Anchor View Estates 2023 Addition; KPB File 2023-116
 Fineline Surveys, Inc. / Kimbrell, Beller
 Location: Shorebird Lane off the Sterling Highway
 Anchor Point Area / Anchor Point APC

# ITEM #1 - PRELIMINARY PLAT ANCHOR VIEW ESTATES 2023 ADDITION

KPB File No.	2023-116
Plat Committee Meeting:	November 13, 2023
Applicant / Owner:	Dmitri Kimbrell and Randy and Sarah Beller, all of Anchor Point, AK
Surveyor:	Dmitri Kimbrell / Fineline Surveys
General Location:	Anchor Point / Anchor Point APC

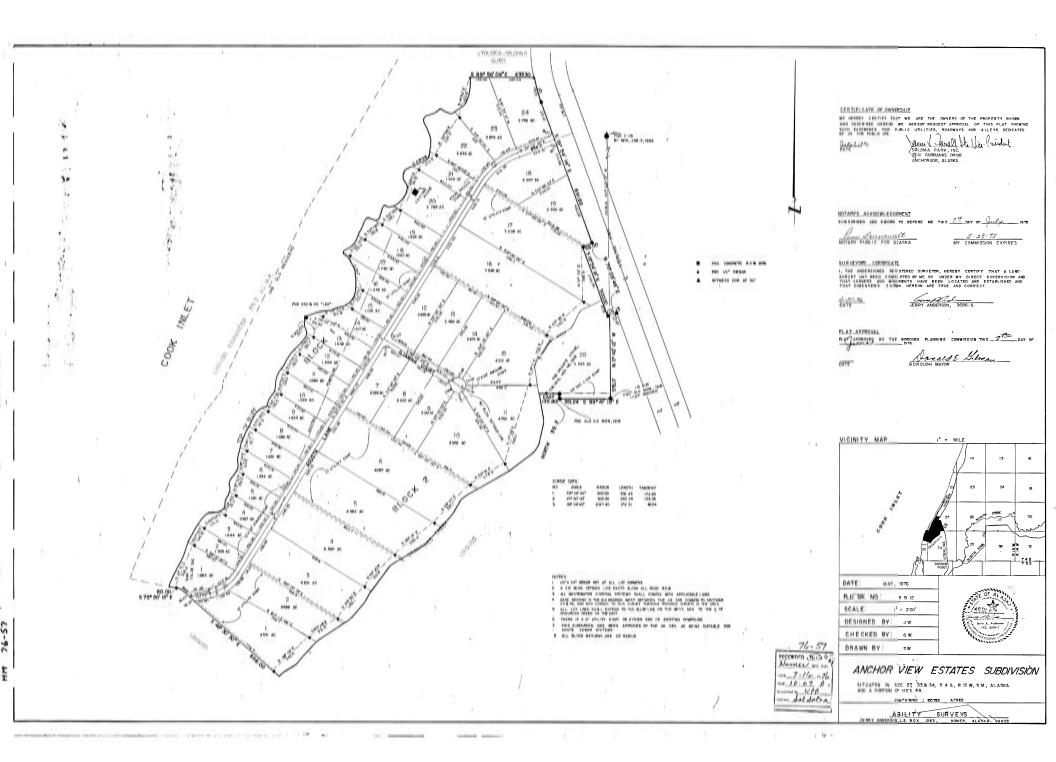
NOTES:  1. A BUILDING SETBACK OF 20 FEET IS REQUIRED FROM ALL STREET RIGHTS OF WAY UNLESS A LESSER STANDARD IS APPROVED BY RESOLUTION OF THE APPROPRIATE PLANNING COMMISSION.  2. THE FRONT 15 FEET OF THE 20 FOOT BUILDING SETBACK AND THE ENTIRE SETBACK WITHIN 5 FEET OF THE SIDE LOT LINES IS A UTILITY EASEMENT NO PERMANENT STRUCTURE SHALL BE CONSTRUCTED OR PLACED WITHIN THE UTILITY EASEMENT WHICH WOULD INTERFERE WITH THE	SECS_27 & 34
ABILITY OF THE UTILITY TO USE THE EASEMENT.  3. THE ACREAGE REPORTED ON THIS PLAT REFERS TO THAT REPORTED ON THE ORIGINAL SUBDIVISION PLAT. LOCATION OF THE TOP OF	T 4S TR 15W SEWARD MERIDIAN SCALE 1"=200" SURVEY
BLUFF AS SHOWN ON PLAT IS APPROXIMATE, ACCORDING TO ORIGINAL PLAT.  4. THE FOLLOWING BLANKET EASEMENTS HAVE BEEN GRANTED TO HOMER ELECTRIC ASSOCIATION	0 100 200
(BK. 17, PG. 14 6/30/1959, BK. 49, PG. 251 6/4/1968)  5. THERE ARE RESTRICTIVE COVENANTS THAT AFFECT THIS SUBDIVISION. (BK 87, PGS 332 & 826)	Depict and label the 10 ft. x 205

ft. electric easement adjoining the northeast boundary of Lot 13
LEGEND:	per serial no. 2003-004614-0 HM.  There is a 5 foot easement within $34 \begin{pmatrix} 7 \\ 2 \\ 6 \end{pmatrix}$ $35$ $36$ $36$
O FOUND 5/8" REBAR	Lot 14 (2003-004615-0 HM) for a full 15 width. The easement
⊕ BRASS CAP MONUMENT 268 1962 6/4 consens ter  ⊕ GLO MONUMENT 1918 51/4 CORNER 527	within Lot 14 does not need to  VICINITY MAP SCALE 1" = 1 MILE  VICINITY MAP SCALE 1" = 1 MILE  VICINITY MAP SCALE 1" = 1 MILE

A. T. C.	CERTIFICATE OF OWNERSHIP:  1 HEREBY CERTIFY THAT I AM THE OWNER OF THE REAL PROPERTY SHOWN AND DESCRIBED FIRM AND THAT I HEREBY ADOPT THIS SUBDIVISION PLA AND BY MY FREE CONSENT GRANT ALL EASEMENTS TO USE SHOWN.
CERTIFICATE OF OWNERSHIP:  WE HEREBY CERTIFY THAT WE ARE THE OWNERS OF THE REAL PROPERTY SHOWN AND DESCRIBED HEREIN AND THAT WE HEREBY ADOPT THIS SUBDIMSION PLAN AND BY OUR FREE CONSENT GRANT ALL EASEMENTS TO USE SHOWN.	Depict and label the underground primary electric line. Provide a label or plat note stating,
	The existing underground powerline is the centerline of a 15-foot-wide electrical distribution line easement
NOTARY'S ACKNOWLEDGEMENT: FOR: RANDY E. BELLER & SARAH D. BELLER	of 11 ask 2 ask 10 including pedestals and transformers, granted this
ACKNOWLEDGED BEFORE ME THIS	plat."
NOTARY PUBLIC FOR ALASKA MY COMMISSION EXPIRES  Depict and label the overhead electric line. Provide	3/

a label or plat note stating a 20 foot utility easement, centered on the	N 84*59*52* E 1986.29* (C)  LOT 6  BLK 2  (HM 76-57)  BL SZURVEYORS CERTIFICATE:  LICENSED TO PRACTICE LAND SURVEYING IN THE STATE  ALASKA, AND THAT THE PLAT REPRESENTS A SURVEY ME  BY ME, AND THAT THE MOVIMENTS SHOWN HEREON  ACTUALLY EXIST AS DESCRIBED, AND THAT ALL DIMENSIS  AND OTHER DETAILS ARE TRUE AND OTHER DET
THIS PLAT WAS APPROVED BY THE KENAI PENINSULA BOROUGH PLANNING COMMISSION AT THE MEETING  DET PLAT APPROVED BY THE KENAI PENINSULA BOROUGH PLANNING COMMISSION AT THE MEETING  DET PLAT APPROVAL.	OF MY KNOWLEDGE AND BELIEF.  ANCHOR VIEW ESTATES 2023 ADDITION.
KENAI PENINSULA BOROUGH	K.P.B. FILE # 2023-  VACATING THE PROPERTY LINES BETWEEN LOTS 10 & 11, AND LOTS 12 & 13, BLOCK 1, ANCHOR VIEW ESTATES, SECTIONS 27 & 34, TOWNSHIP 4 SOUTH, RANGE 15 WEST,
BY: AUTHORIZED OFFICIAL:	SEWARD MERIDIAN, KENAI PENINSULA BOROUGH, ALASKA. HOMER RECORDING DISTRICT. containing 6.314 acres.
